A REPAIR

ON-SITE SEWAGE DISPOSAL SYSTEM - EVALUATION HOWARD COUNTY HEALTH DEPARTMENT BUREAU OF ENVIRONMENTAL HEALTH

ADDRESS: 12832 Highland Road PROPERTY OWNER: O'Leary

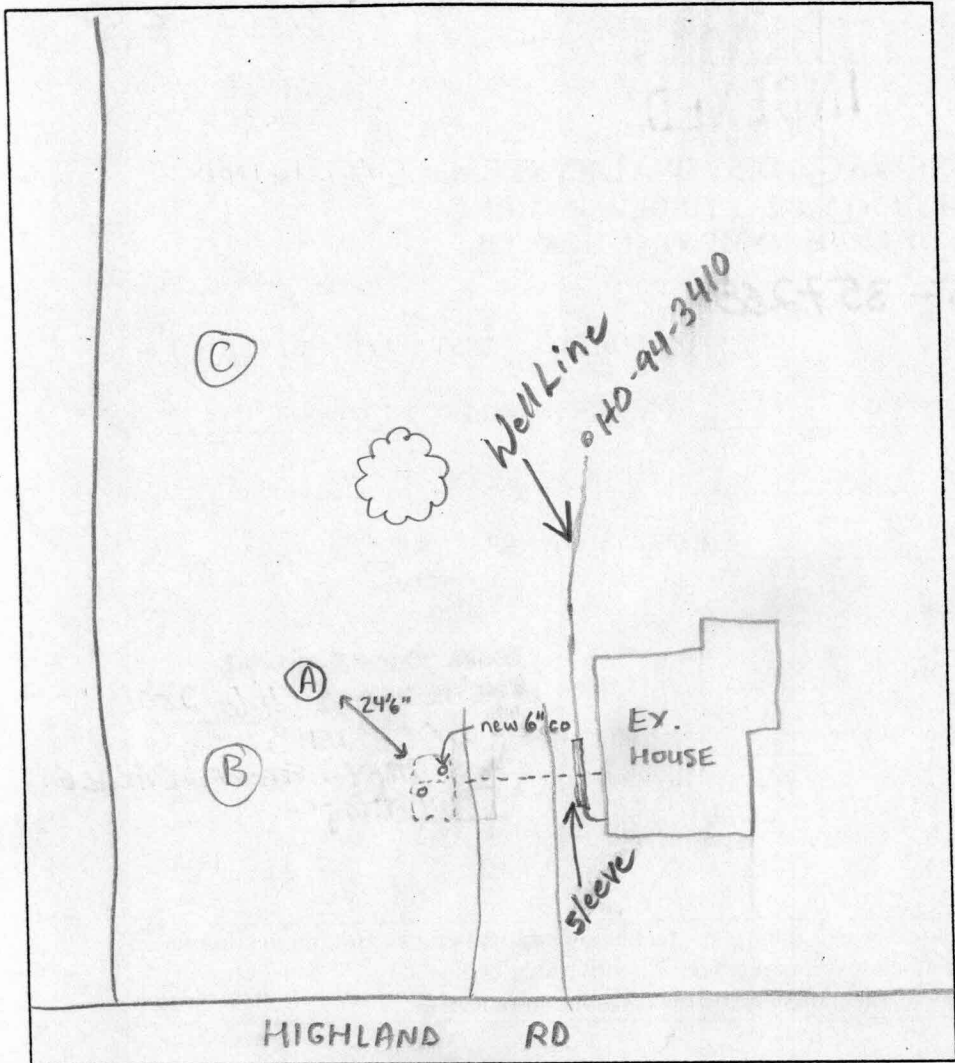
PRE-CONSTRUCTION INSPECTION: 9/19/01 - MET OWNER (MR. O'LEARY) & JACK FYOCK, EX. TANK PARTIALLY EXCAVATED, APPEARS TO BE HOME-MADE AND COMPARTMENTED, CAPACITY EST. TO BE 2000 GALLONS, NO EVIDENCE OF SURFACE DISCHARGE, PERC HOLE DUG IN LOCATION (A) SEE SOIL PROFILE, REPAIR EXISTS
 INSPECTION COMMENTS: IN LOCATION (B) & (C), NEW WELL SITE & GARAGE WILL HAVE TO WORK AROUND REPAIR AREA (SRV)

12832 HIGHLAND ROAD

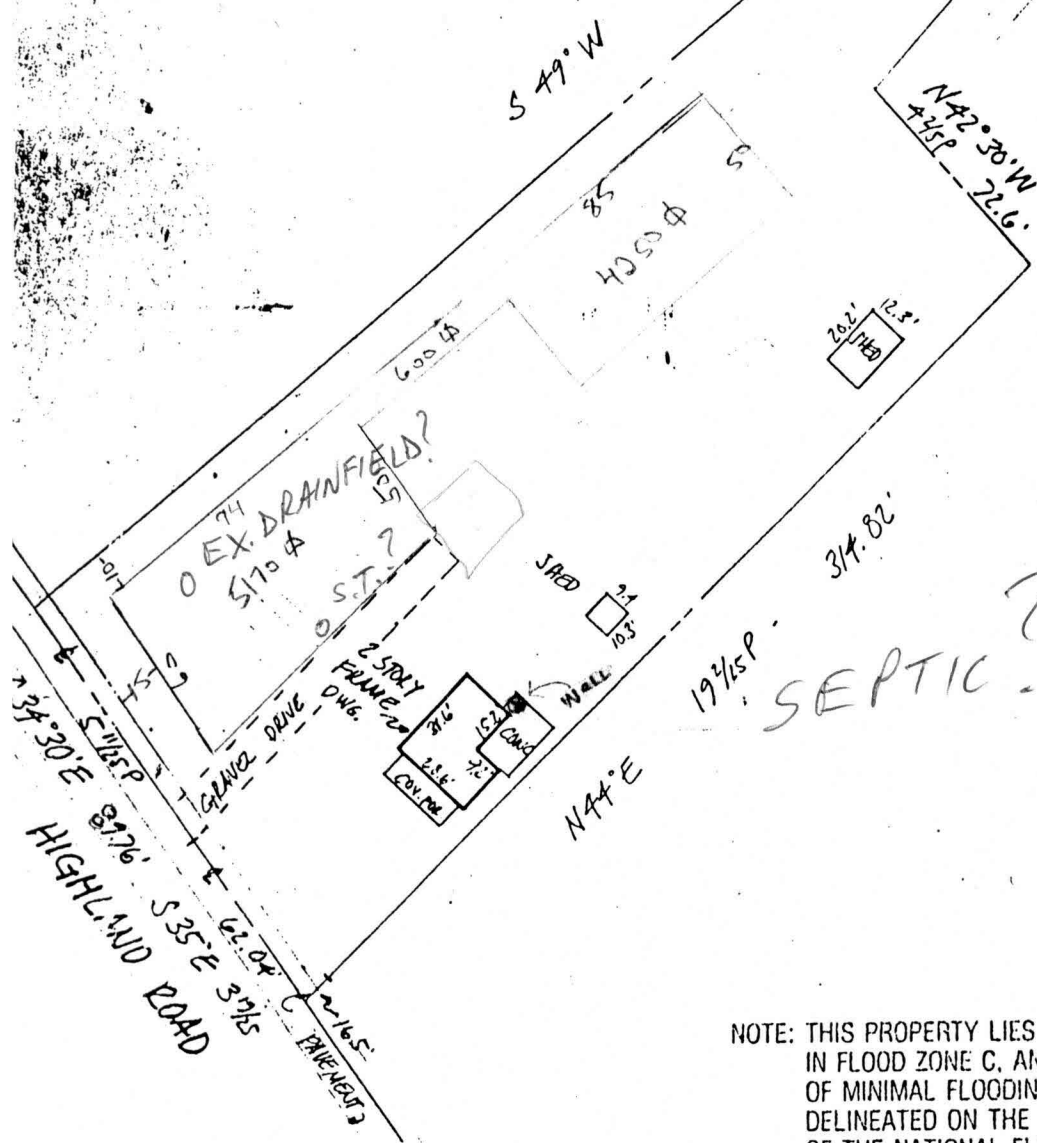
8/17/01 MET W/OWNER O'LEARY
 RE: ADD'N W/ 1 NEW BR, & DELETION
 OF 1 EX. BR (FINISHED TOTAL 3BR)
 WELL REPL & AB. REQ'D BY BP
 PERC TO EST. REPAIR AREA &
 S.S. LOCATION/DESIGN
 REQ'D BEFORE WELL PERMIT
 NO OTHER PROBLEMS
 FORESEEN
